Economic Commission for Europe**Inland Transport Committee****World Forum for Harmonization of Vehicle Regulations****Working Party on Lighting and Light-Signalling****Eighty-first session**

UN Regulations Nos. 37 (Filament lamps), 99 (Gas discharge light sources), 128 (Light emitting diodes light sources) and the Consolidated Resolution on the common specification of light source categories**Proposal for amendment [6] to the Consolidated Resolution on the common specification of light source categories (R.E.5)****Submitted by the expert from the International Automotive Lighting and Light Signalling Expert Group (GTB)***

The text reproduced below was prepared by the expert from GTB with the aim to introduce new light emitting diode (LED) substitute light source categories C5W/LEDK and R5W/LED in the Consolidated Resolution on the common specification of light source categories (R.E.5) (ECE/TRANS/WP.29/1127). The modifications to the existing text of the Resolution are marked in bold for new or strikethrough for deleted characters. This proposal is supported by informal document GRE-81-03.

Figure 1
Main drawing

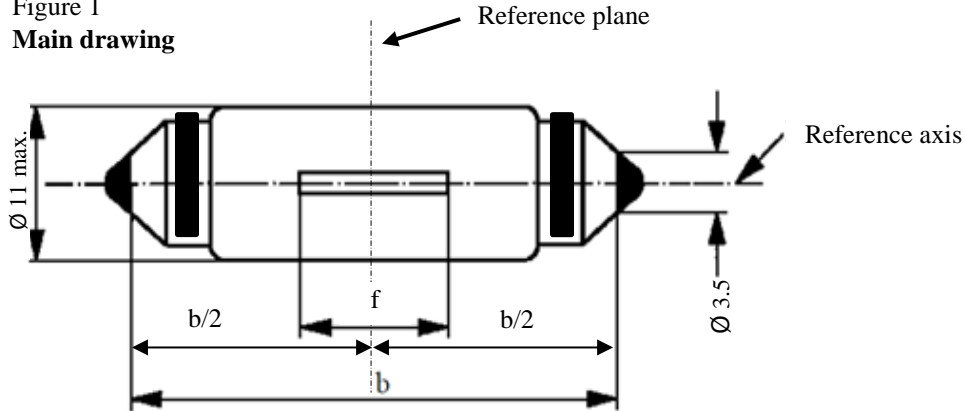
Before sheet LR1/1, insert new sheets C5W/LED/1 to 4, to read (see following pages; one page per sheet):

Dimensions in mm		LED light sources of normal production			Standard LED light source
		min.	nom.	max.	
b ^{1/}		34.0	35.0	36.0	35±0.5
e ^{2/}			0.0		0.0
f ^{2/}			9.0		9.0
Cap SVX8.5 in accordance with IEC Publication 60061 (sheet 7004-81A-1)					
Electrical ^{3/} and photometric characteristics					
Rated values	Volts	12			12
	Watts	2			2
Test voltage	Volts	13.5			13.5
Objective values	Watts	2 max.			2 max.
	Electrical current (in mA at 9-16V DC)	30 min. 170 max.			
	Luminous flux ^{3/} (in lm at 13.5 V DC)	45 ± 20 % ^{4/}			45 ± 10 % ^{4/}
	Luminous flux ^{3/} (in lm at 9 V DC)	9 min.			9 min.

Figure 2

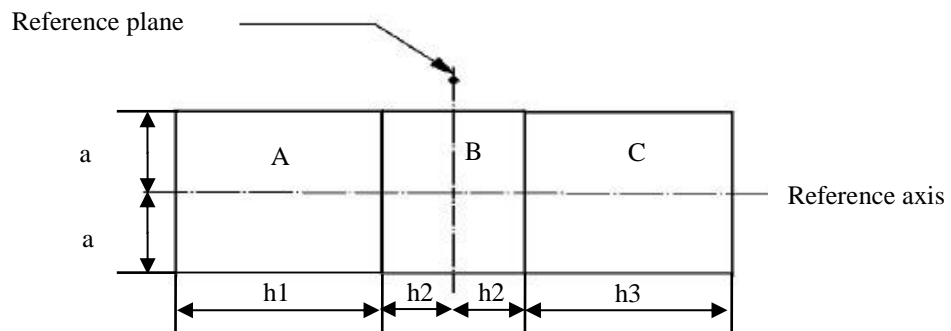
The proportion of the total luminous flux emitted into these viewing directions from the area(s) as defined in figure 2:

- A, B and C together shall be 70 per cent or more;
- B shall be 20 per cent or more;
- A and C shall each be 15 per cent or more.

<i>Dimension (mm)</i>	<i>a</i>	<i>h1, h3</i>	<i>h2</i>
All views (as specified above)	2.5	6	2

Figure 3

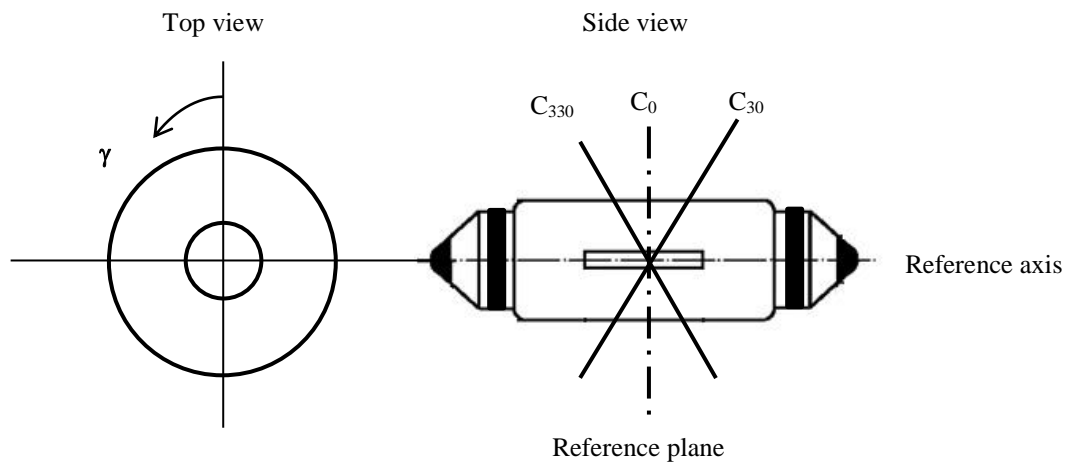
The following test is intended to determine the normalized luminous intensity distribution of the light source in the C-planes as described in figure 3. The intersection of the reference axis and the reference plane is used as the coordinate system origin.

The measurements shall be performed in C-planes, where C_0 shall be the reference plane of the light source. The C-planes to be measured shall be C_0 , C_{30} and C_{330} . The test points for each plane and multiple polar angles γ are specified in Table 3.

Figure 1
Main drawing

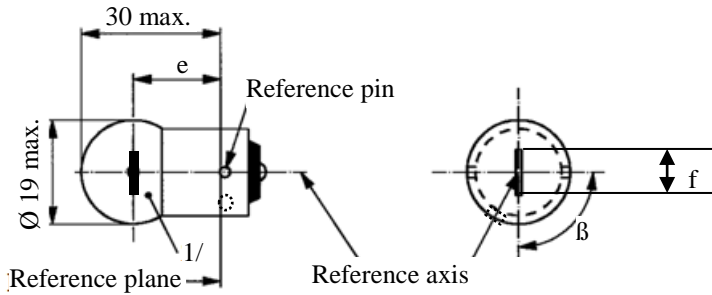
After sheet PY21W/LED, insert new sheets R5W/LED/1 to 4, to read (see following pages; one page per sheet):

Dimensions in mm		LED light sources of normal production			Standard LED light source
		min.	nom.	max.	nom.
e ^{2/}			19.0		19.0
f ^{2/}			4.0		4.0
β ^{2/}			90°		90°
R5W/LED: Cap BA15s-3(110°) in accordance with IEC Publication 60061 (sheet 7004-19A-1)					
Electrical and photometric characteristics		4/		5/	
Rated values	Volts	12		24	
	Watts	2		2	
Test voltage	Volts	13.5		28.0	
	Watts	2 max.		2 max.	
Objective values	Electrical current (in mA)	(at 9-16V DC) 30 min. 170 max.	(at 16-32V DC) 30 min. 170 max.	(at 9-16V DC) 30 min. 170 max.	
	Luminous flux ^{1/, 3/} (in lm at 13.5 V DC)	50 ± 20 %			50 ± 10 %
	Luminous flux ^{1/} (in lm at 9 V DC)	10 min.		10 min.

Figure 2

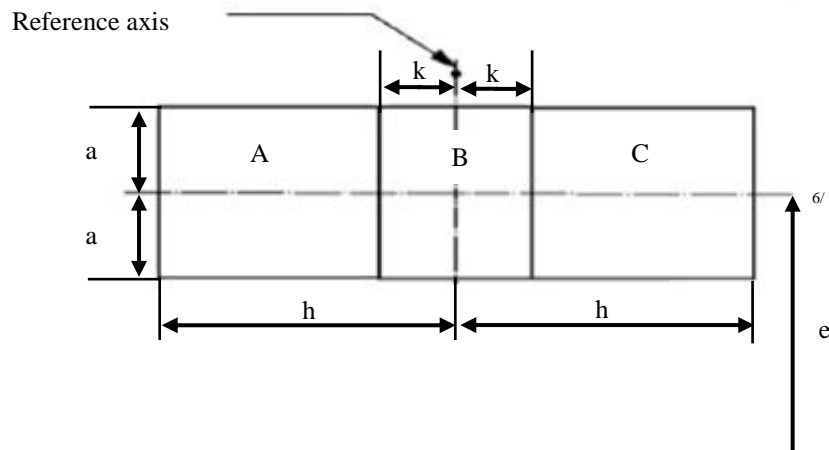
The proportion of the total luminous flux emitted into these viewing directions from the area(s) as defined in figure 2:

- A, B and C together shall be 70 per cent or more;
- B shall be 20 per cent or more;
- A and C shall each be more than 15 per cent.

<i>Dimensions in mm</i>	<i>a</i>	<i>h</i>	<i>k</i>
Top view ($\gamma = 0^\circ$)	3	4	0.5
Inclined views ($\gamma = \pm 45^\circ$)	4.5	4	0.5
Front/ Rear view ($\gamma = \pm 90^\circ$)	3	4	0.5

Figure 3

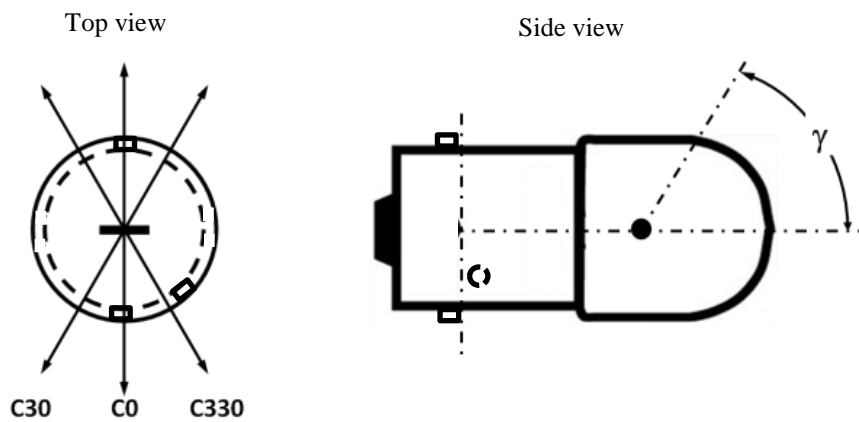
The following test is intended to determine the normalized luminous intensity distribution of the light source in the C-planes as described in figure 3. The intersection of the reference axis and the parallel plane to the reference plane in distance e is used as the coordinate system origin.

The measurements shall be performed in C-planes, which contain the reference axis of the light source. The C-planes to be measured shall be C₀, C₃₀ and C₃₃₀. The test points for each plane and multiple polar angles γ are specified in Table 3.
